**CALIFORNIA COASTAL COMMISSION**

**STAFF REPORT: REGULAR CALENDAR**  
**AND DE NOVO ACTION ON APPEAL**

**APPLICATION NUMBER:** 5-02-334      **APPEAL NUMBER:** A-5-PPL-02-276

**PROJECT LOCATION:** 17633 Castellammare Drive, Pacific Palisades (Los Angeles County)

## SIDE ELEVATION

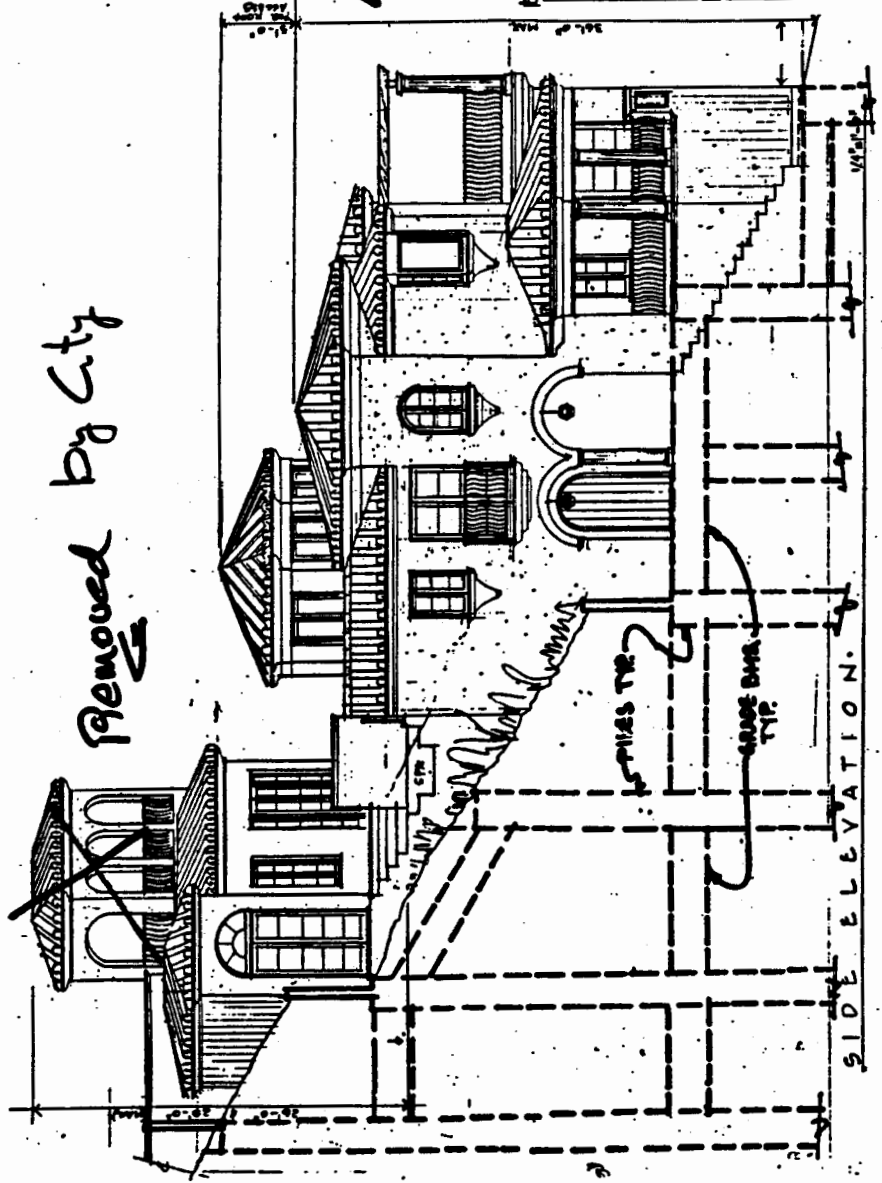
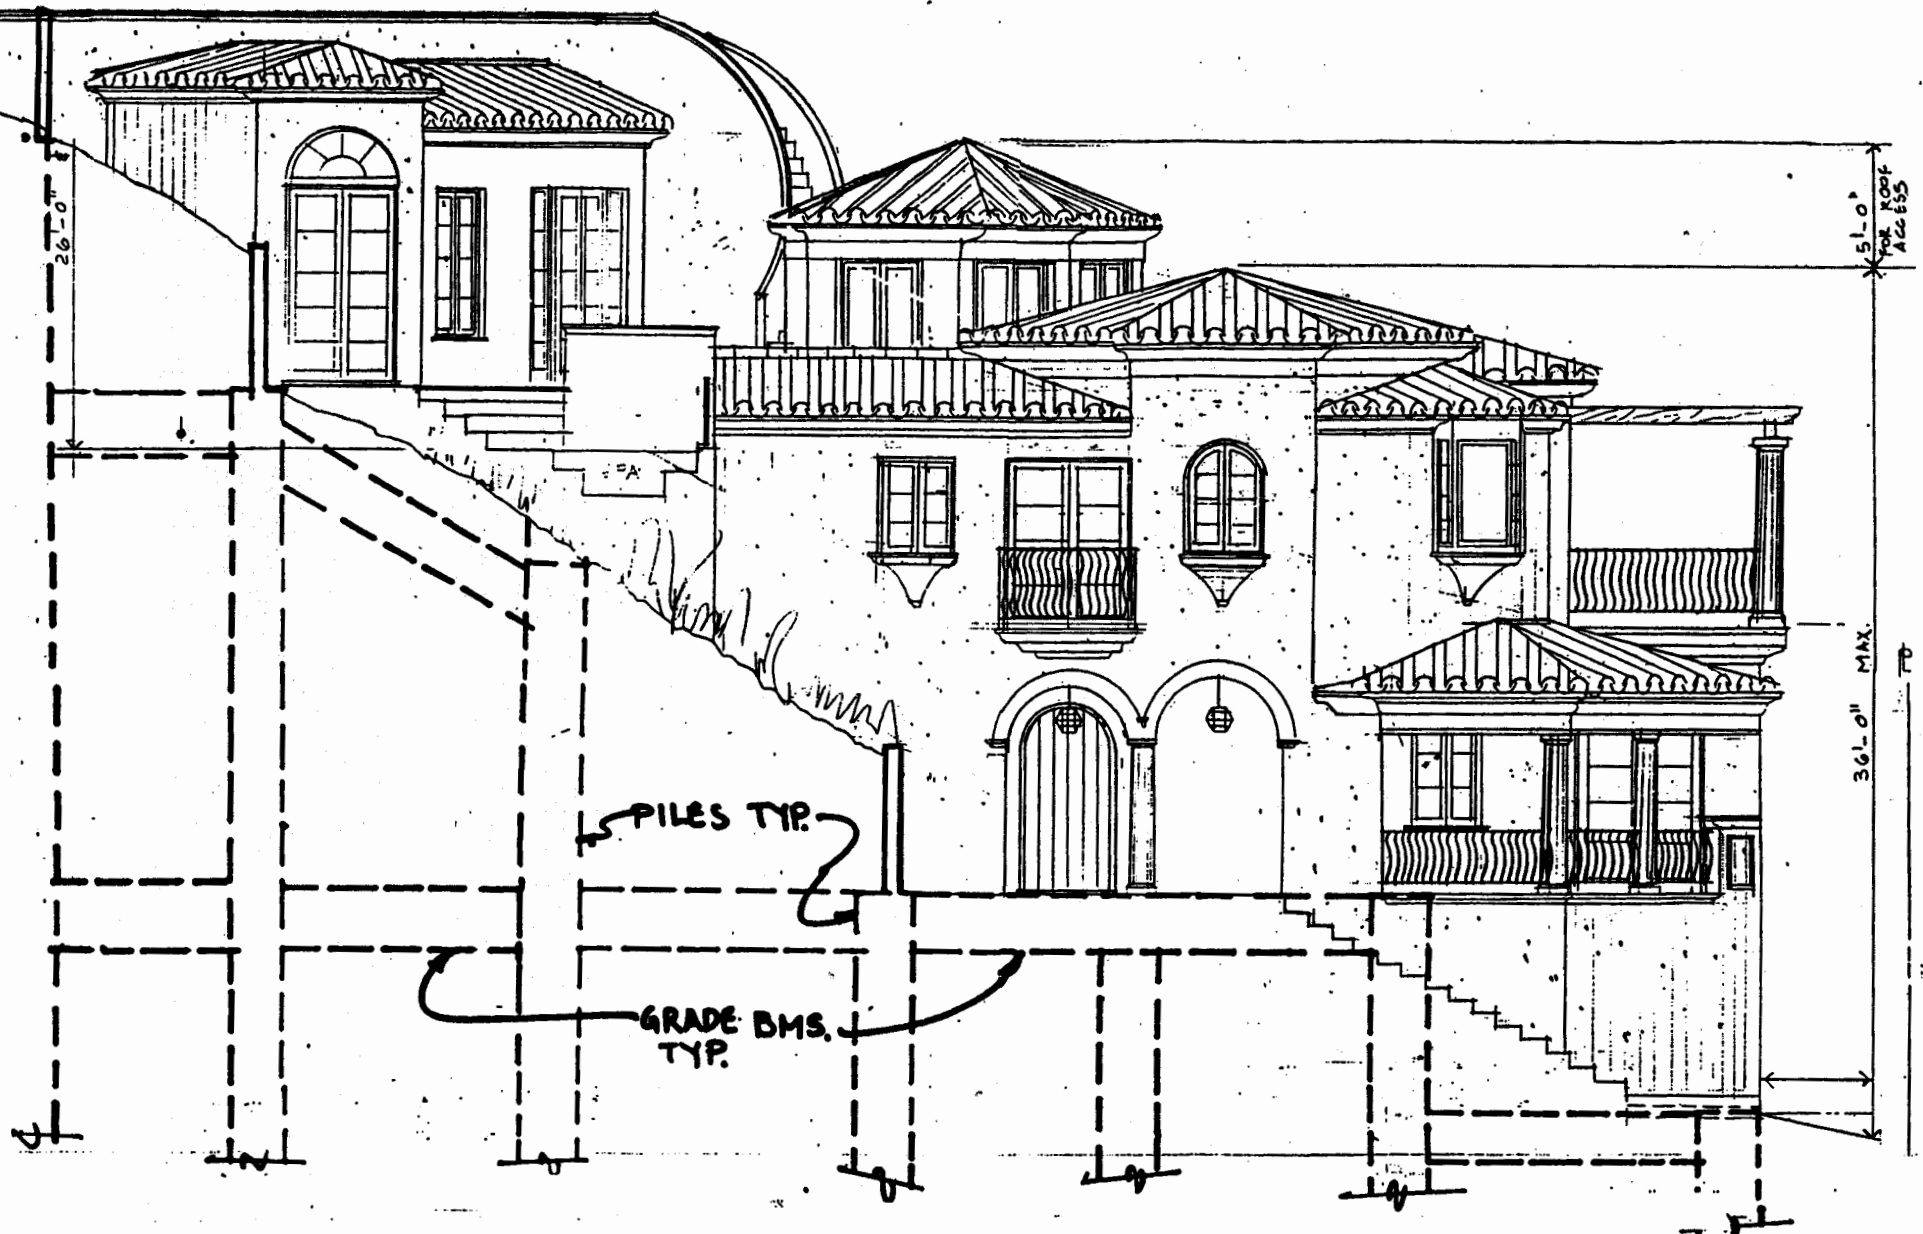
Original  
proposal

Removed by City

**Plate 1. Postulated Posetano Road Landslide.**

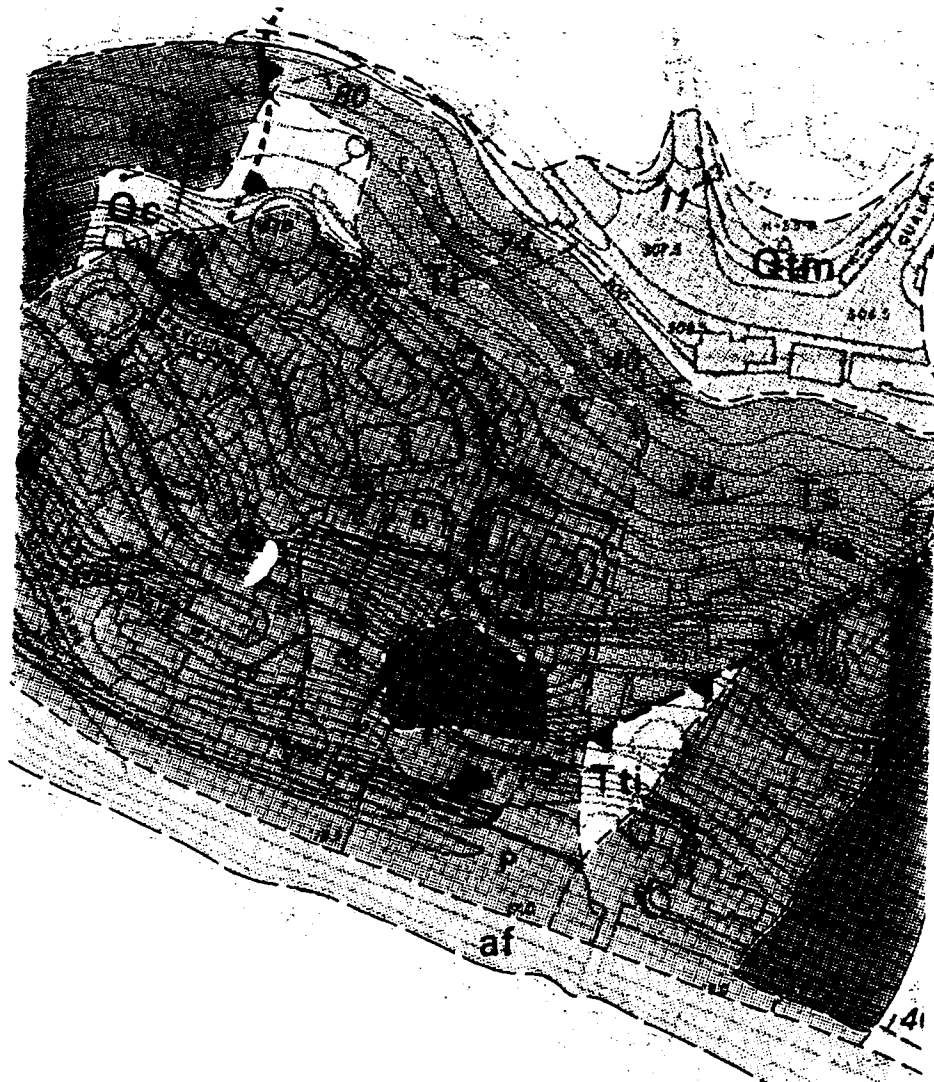
More relevant for present purposes is evidence that the movement is now also apparent in the property adjacent to that of Clearihue on the west at 17712 Revello Drive. There fractures in the southeastern corner of the house foundation (Photo 1 in Appendix B), and in a retaining wall at the western side of the property (Photo 2 in Appendix B), show

that the crown of the landslide now extends west of the Clearihue property. Plate 1, adapted from McGill's 1989 map shows the apparent boundaries of the Posetano Drive landslide as currently interpreted. This interpretation is based not only on observed damage to structures along the landslide crown, but also indications of dilation at the base of the slide along Porto Marina Way (See Photos 3, 4, 5 and 6, Appendix BA).
